Consultant: dar making progress together	THIRD SAUDI EXPANSION OF THE HOLY MOSQUE & SURROUNDING AREAS	Contractor: مجموعة بن لادن السعودية SAUDI BINLADIN GROUP Haramain Division قطاع الحرمين الشريفين
Project Ref:1150		Issue Date: 24-NOV-2025

WORK INSPECTION REQUEST (WIR)	WIR Reference No.	Rev.
	SHE-CUC-EL-10426	00

Project Name: ....Makkah Haram Shamiya Expansion CUC...

Pulling fiber Optic cable (12C Fiber Optic Cable SM 9/ 125 OS2, Loose Tube, Glass Armour In-door/Outdoor LSOH Sheath) from 01-RTU-EC-01 to 01-RTU-M3-04 in Chiller building Area as per detail and highlighted drawings.

Drawing No.
CUC-SD-SA-C02-BM-1220

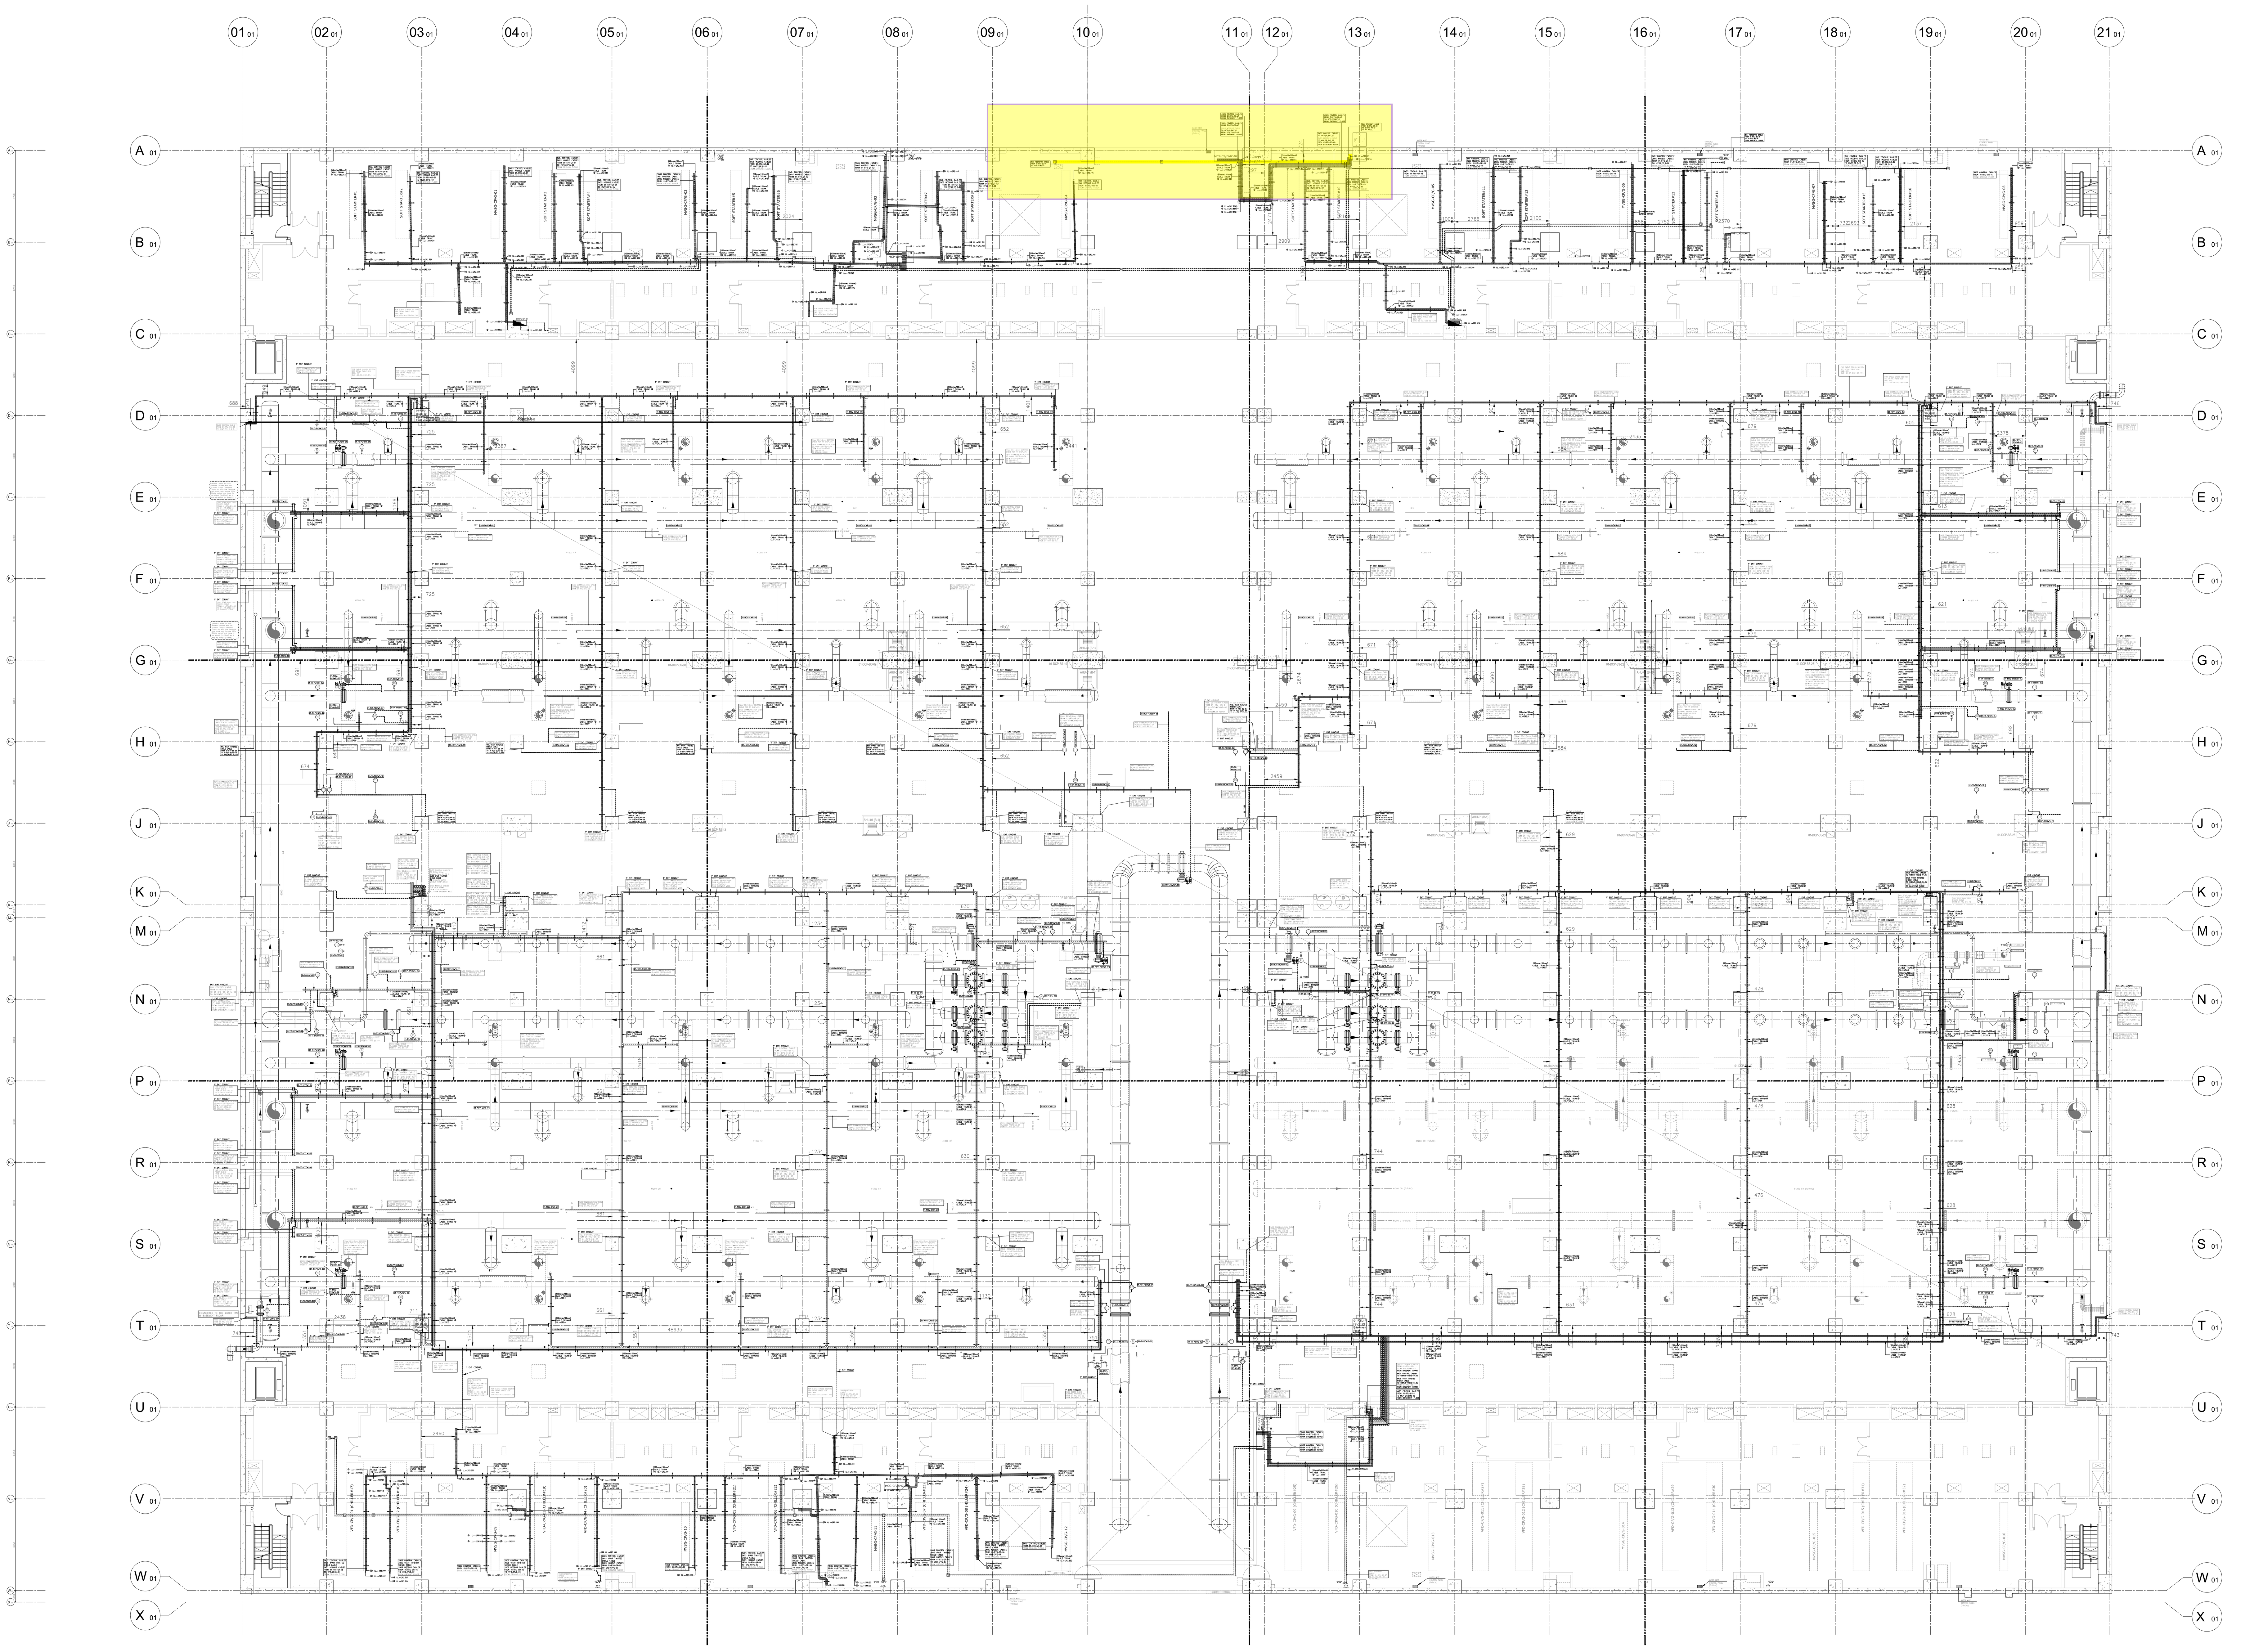
LC Comments:-
** Refer to Comments on DWG #
CUC-SD-SA-C02-BM-1221-04.
23/10/2017

SCADA (B)
Refer to SCADA General Comments on DWG #
CUC-SD-SA-C02-BM-1221
24/10/2017

* Refer to the Comments on the Part Plans & (Previous Revision)
* Refer to the Comments on the Drawing Ref:
(CUC-SD-SA-C02-BM-1228-R04)
The Contractor is held responsible for Any deviation or remedy Works In the Site due to any Unclouded Change.

Drawing No.
CUC-SD-SA-C02-B1-1120

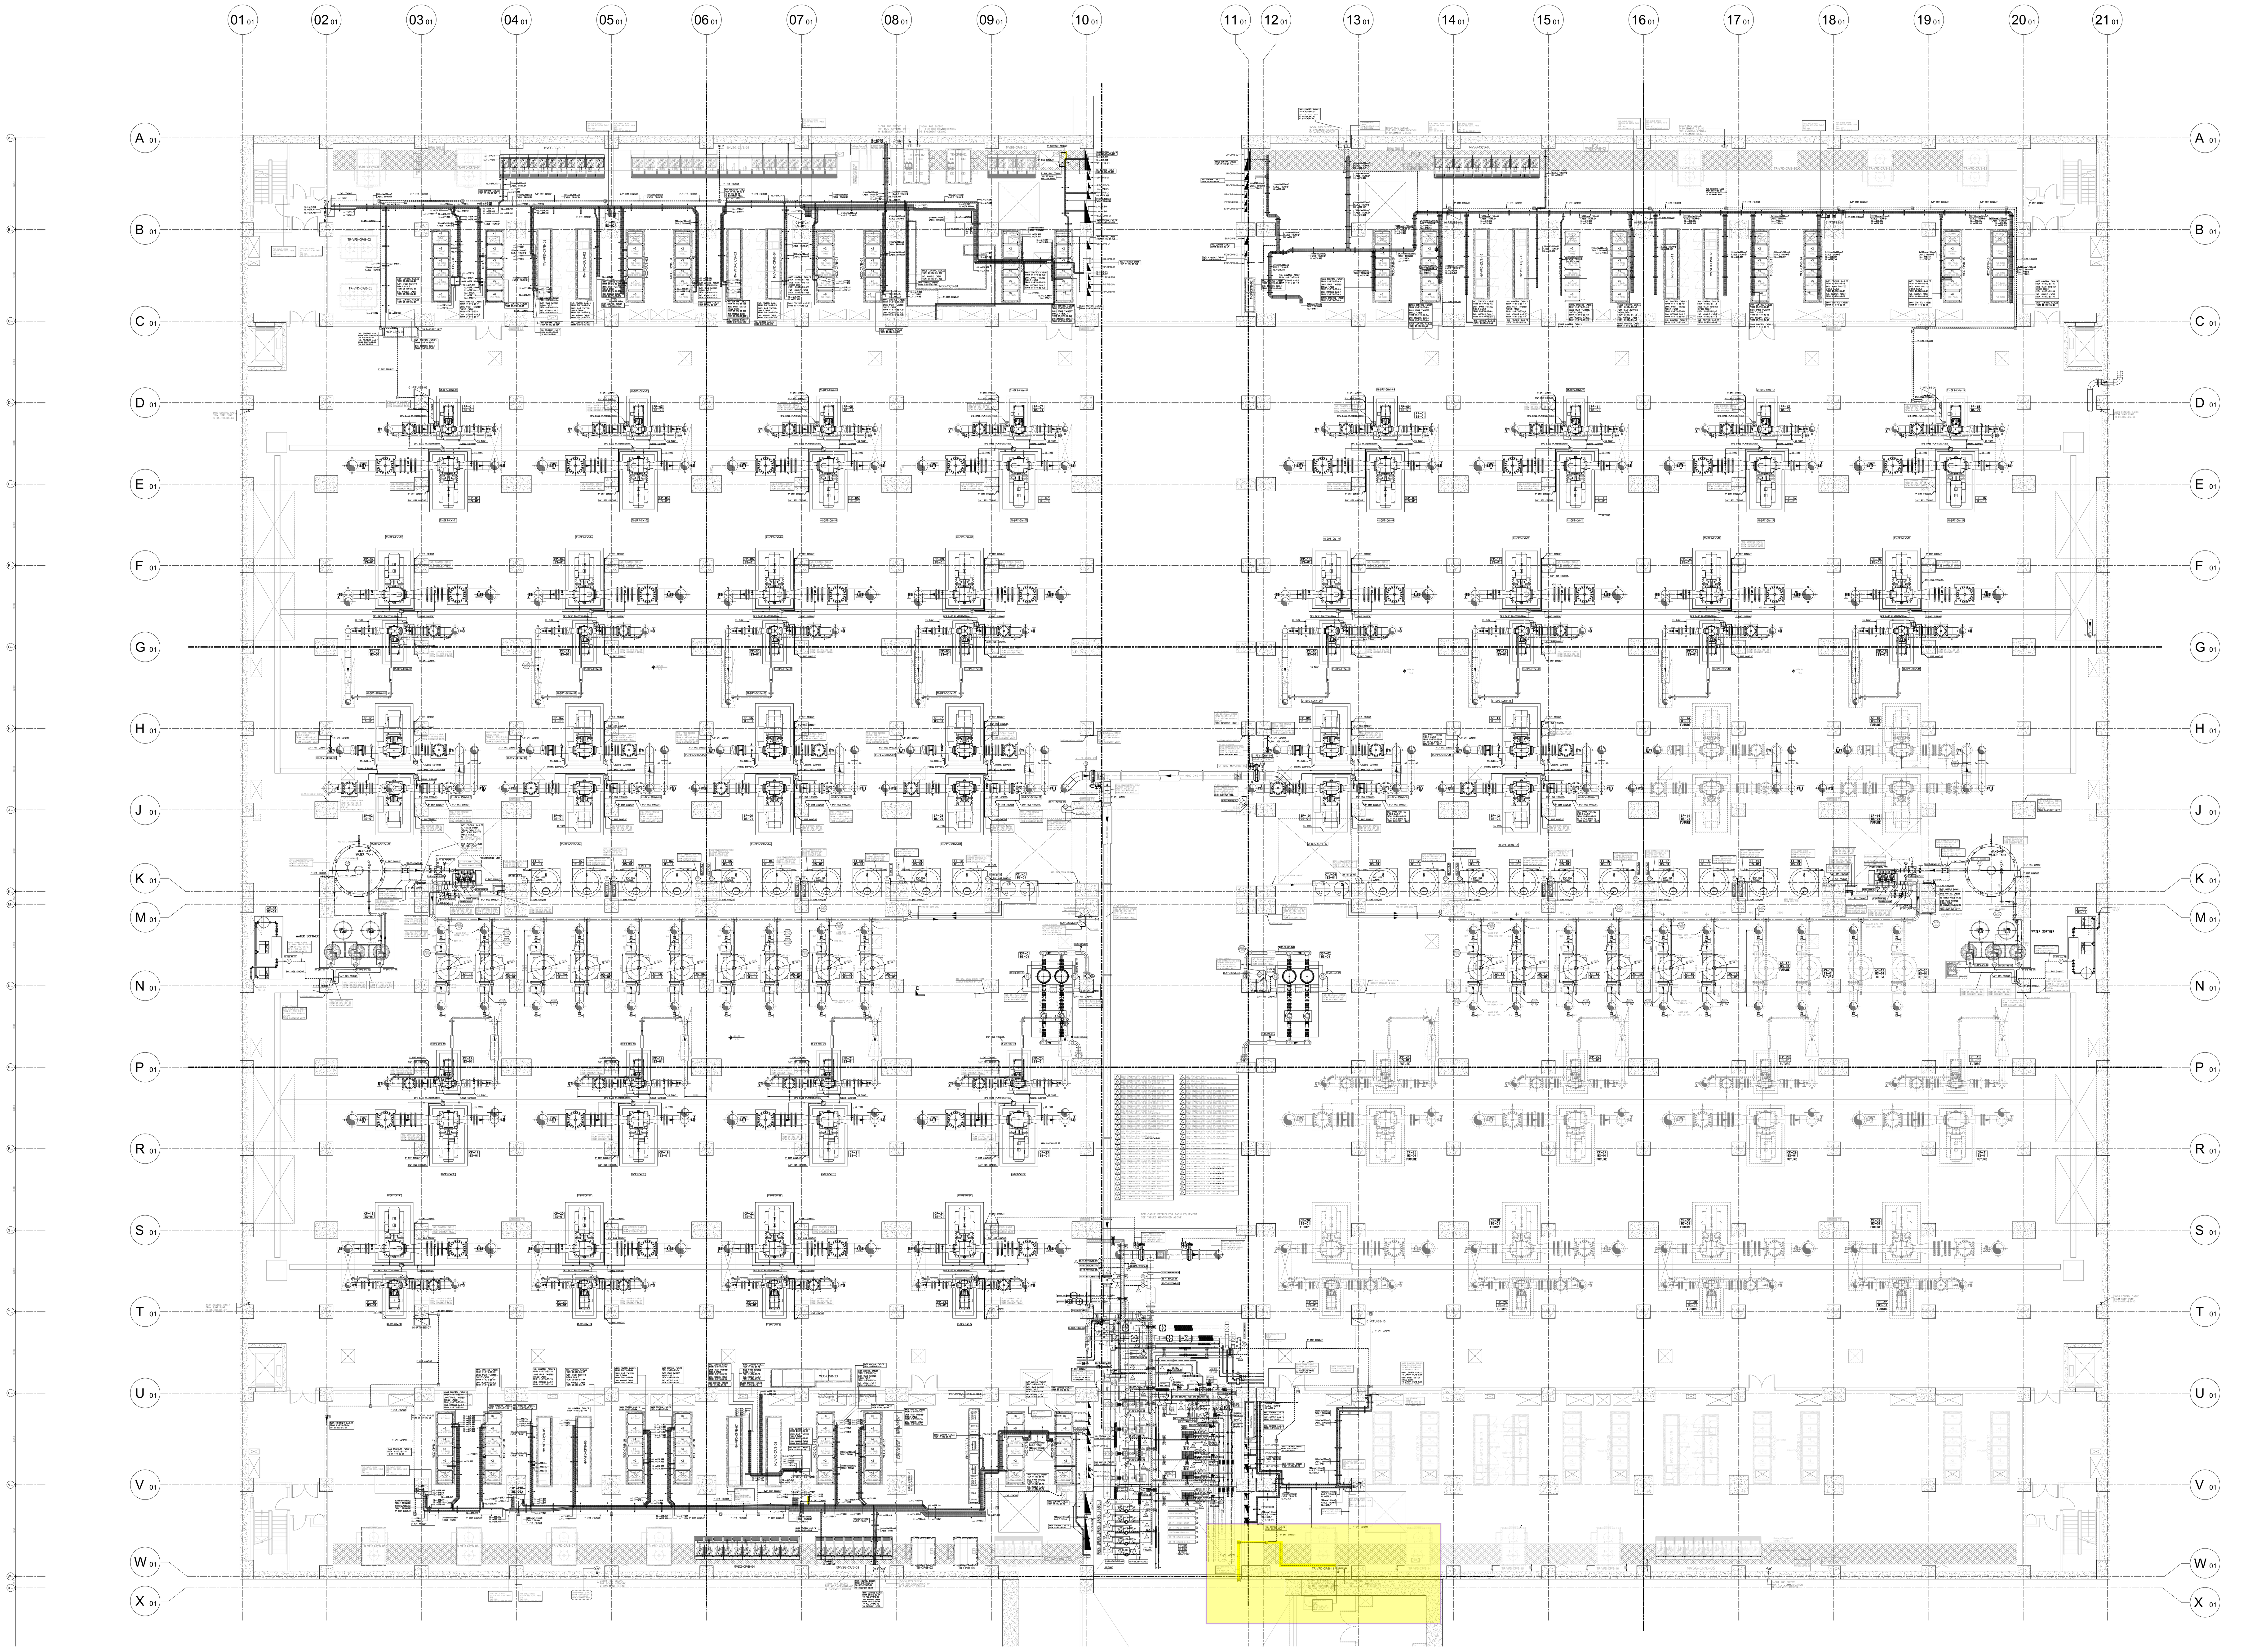
SCADA (B)

Refer to SCADA General comments on DWG #
CUC-SD-SA-C02-00-0302

1- Hence, there is no marked-up clouds indicating the modifications, Any modification done without the marked-up clouds will be the contractor responsibility and the consequent remedy work shall be done without any extra cost to the client.

4- Refer to comments given to partial plans S.D#
(CUC-SD-SA-C02-B1-1121-R04) to
(CUC-SD-SA-C02-B1-1124-R04) and from S.D#
(CUC-SD-SA-C02-B1-1129-R04) to S.D#
(CUC-SD-SA-C02-B1-1131-R04)
